Safety Improvement Project
Haverhill Road (Route 110)
Application for Permit to Access State
Highway

Amesbury,
Massachusetts

MassDOT Submittal Letter

Response to 100% Comments

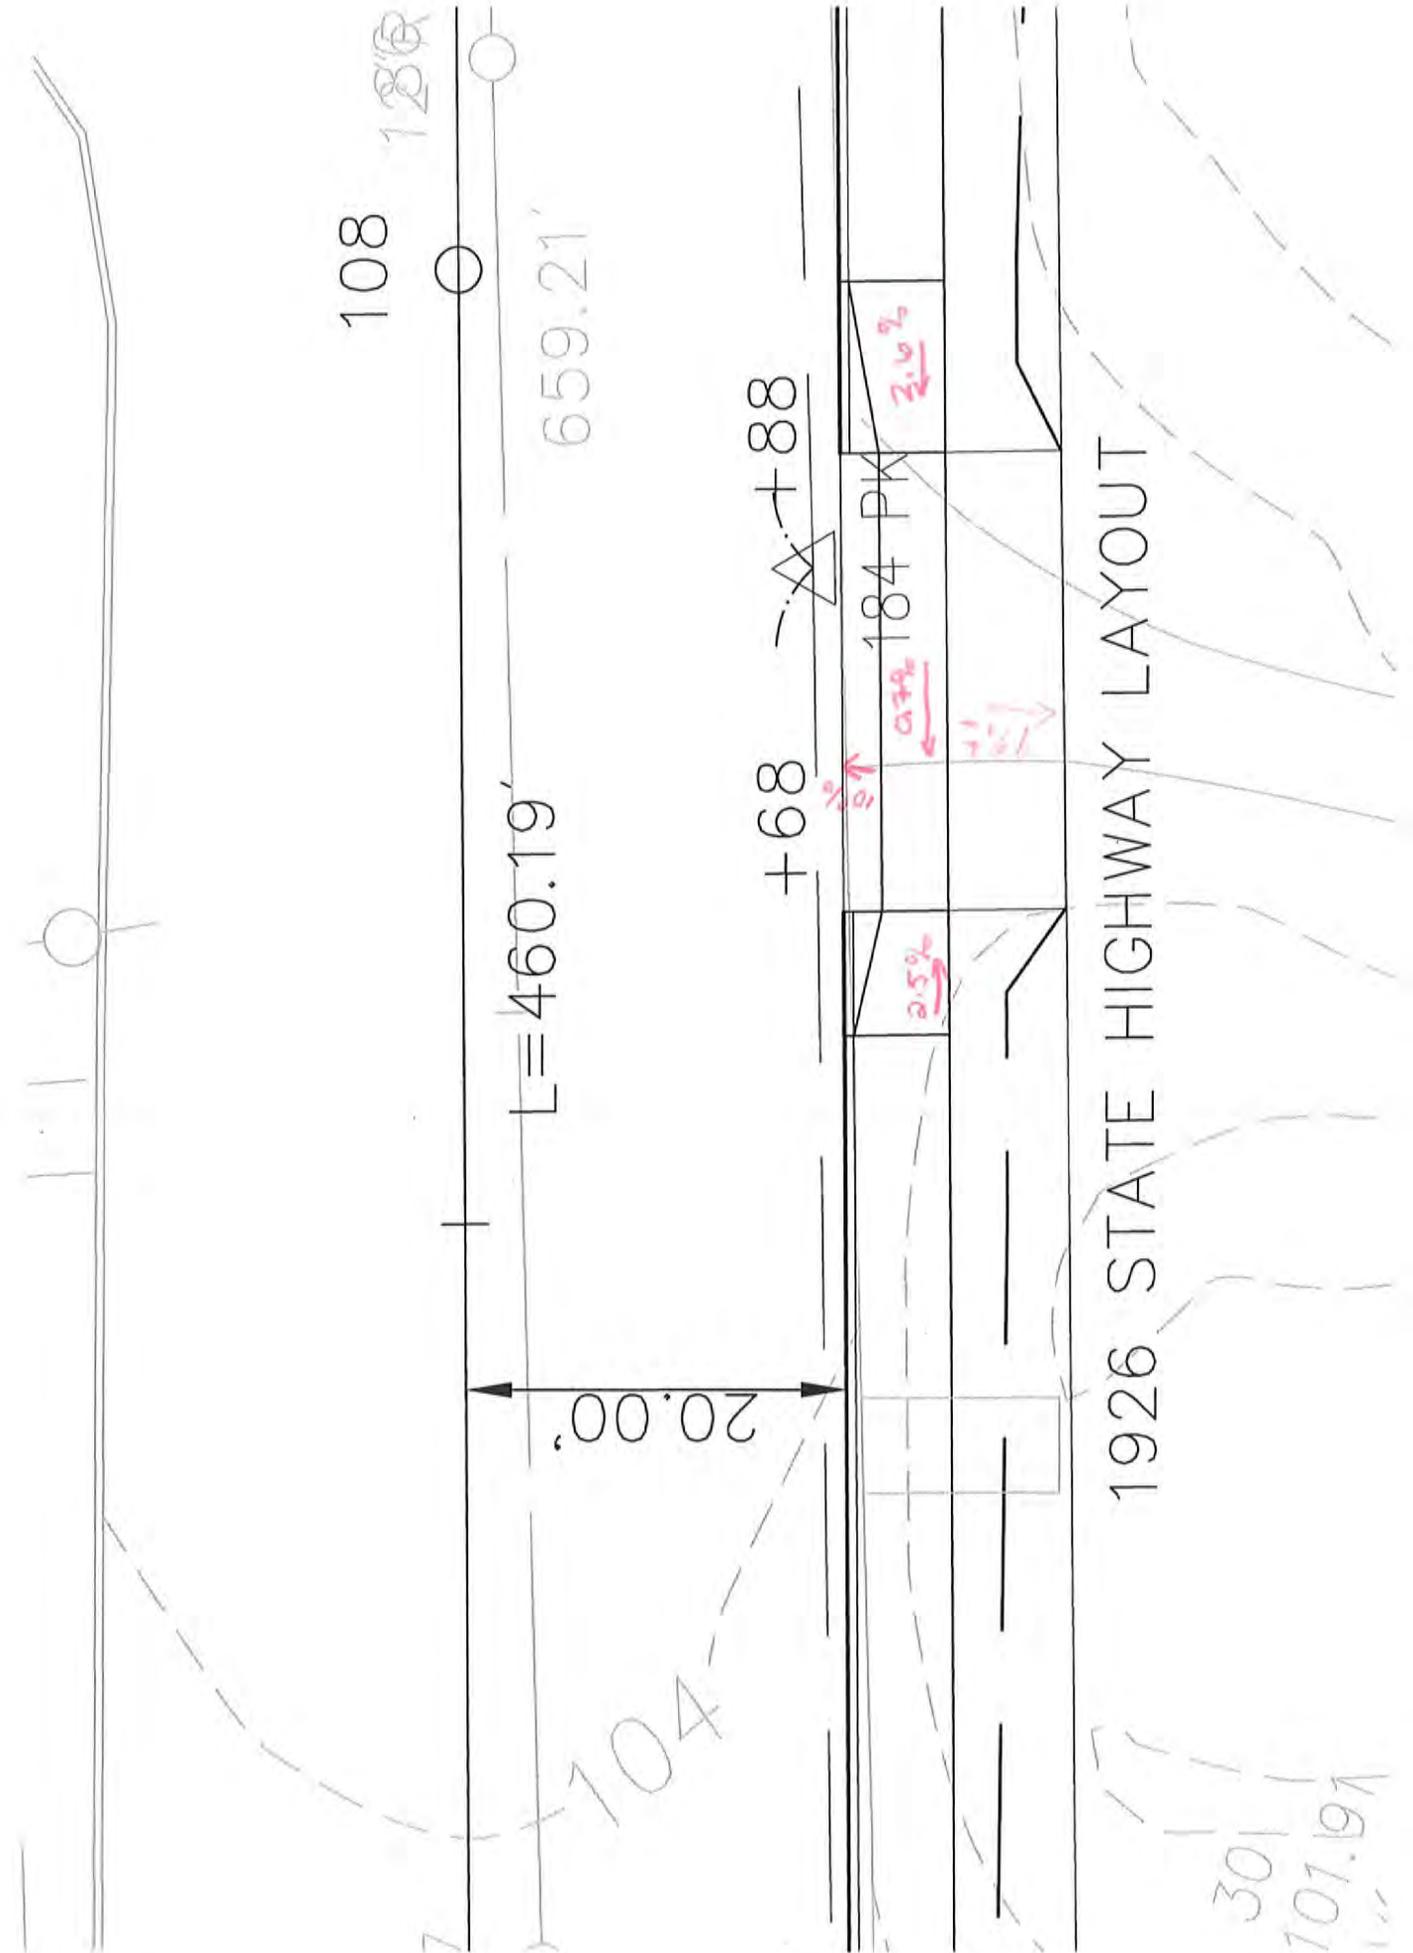
I am okay with the design shown in the sketches (with a 10% driveway slope). The detail will have to be revised because it shows a max. 8.3% slope for the driveway. I would be happy with that part of the driveway labelled as “10% to 15% varies”. It is only 2’ long so it won’t be an obstacle for vehicles.

We have reviewed the driveway grading in response to the comment we received on Thursday August 4th from District Projects Sections.

If we assume a 10% entrance ramp grade for 2 feet (as designed) the grade of the wing ramps on both driveways is less than 5%; actually the grade of three of the ramps is less than 3% (please see attached sketch – I have also attached the design plans for quick reference). The 7.5% max. grade in the detail is included for the contractor, in case the field conditions are different from the survey so that the ramps will be designed to meet ADA/AAB.

We evaluated moving the sidewalk away from the road as recommended in the comment but due to grading behind the sidewalk and ROW restrictions we would not be able to maintain an offset sidewalk especially around Sta. 108+00 so the sidewalk path would be circuitous and more difficult to navigate. Additionally, we do not recommend that a sidewalk constructed adjacent to the edge of road and Vertical granite curb, veer away from the edge of road. This may confuse and disorient a blind or otherwise handicapped person.
